Project: HVAC replacement project, Group 1

BID ADDENDUM 2

HVAC IMPROVEMENTS GROUP 1 – 4 SITES
VICTOR ELEMENTARY SCHOOL DISTRICT
VICTORVILLE, CA

EXHIBIT B - ADDENDUM – 02

MECHANICAL RENOVATION FLOOR PLAN - RELOCATABLE (DUAL UNIT)

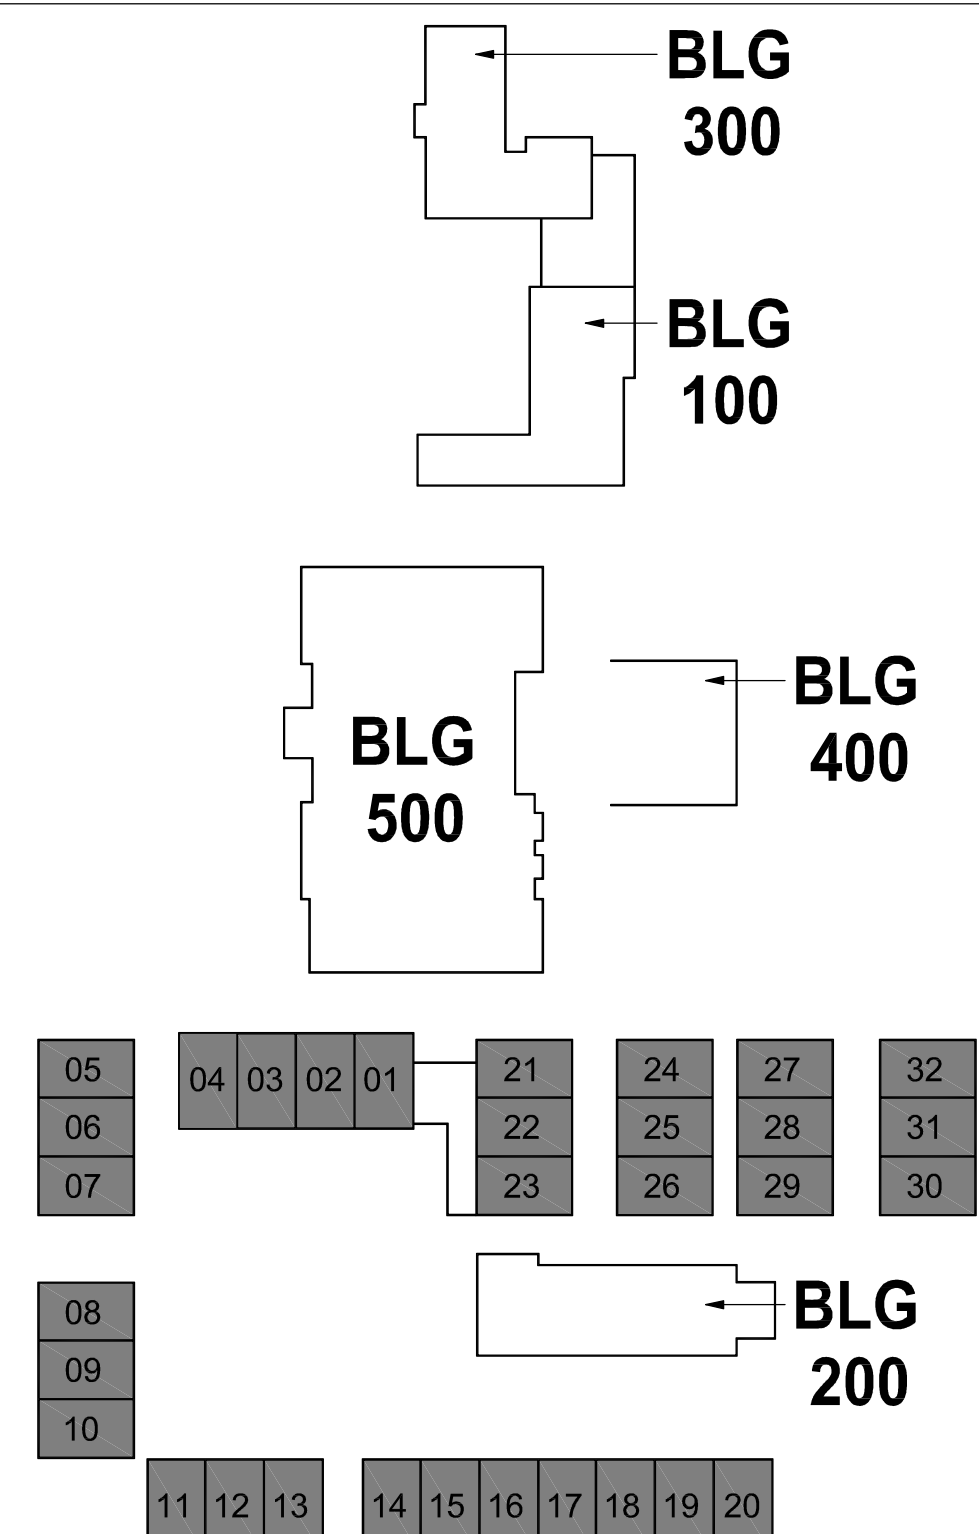
1. **M0-1.2 – Mechanical Schedules**
 - a. Comparison Schedule – revised sound curb weight and total weight.
 - b. Air Conditioner Schedule (wall mounted) – revised sound curb model number. Revised operating weight. Added remark No. 6.
2. **MD2-1.5 – Mechanical Demolition Floor Plan – Relocatables**
 - a. Added existing top supply air duct for clarification.
 - b. Revised Demolition Note No. 1.
3. **M2-1.5 – Mechanical Renovation Floor Plan - Relocatables**
 - a. Added 'graphic' of existing exposed supply air duct at top of unit.
 - b. Revised Plan Note No. 1 to clarify reconnection to top of unit air supply.

- 1.- WALL MOUNTED GAS-ELECTRIC AIR CONDITIONING UNIT COMPLETE WITH SOUND CURB. RECONNECT TO EXISTING MODIFIED SUPPLY AIR DUCTWORK LOCATED ABOVE UNIT. RECONNECT TO EXISTING MODIFIED RETURN AIR DUCTWORK IN WALL. THE NEW BARD UNIT IS SHORTER IN LENGTH (BY 2") THAN THE EXISTING UNIT. AFTER INSTALLATION OF THE REPLACEMENT UNIT, PATCH, REPAIR AND PAINT THE AREA OF REMOVAL OF THE OLDER UNIT INCLUDING THE ANCHOR HOLES TO MATCH THE SURROUND WALL SURFACE TO THE SATISFACTION OF THE OWNER. SEE SCHEDULE ON SHEET M0-1.2, DETAIL 5/MD-2.1 AND GENERAL NOTE ON THIS SHEET FOR ADDITIONAL INFORMATION. RECONNECT LINE SIZE GAS (SCH. 40 BLACK STEEL) COMPLETE WITH A LISTED YELLOW FLEXIBLE CONNECTOR, S.O.C., UNION AND 6" DIRT LEG.
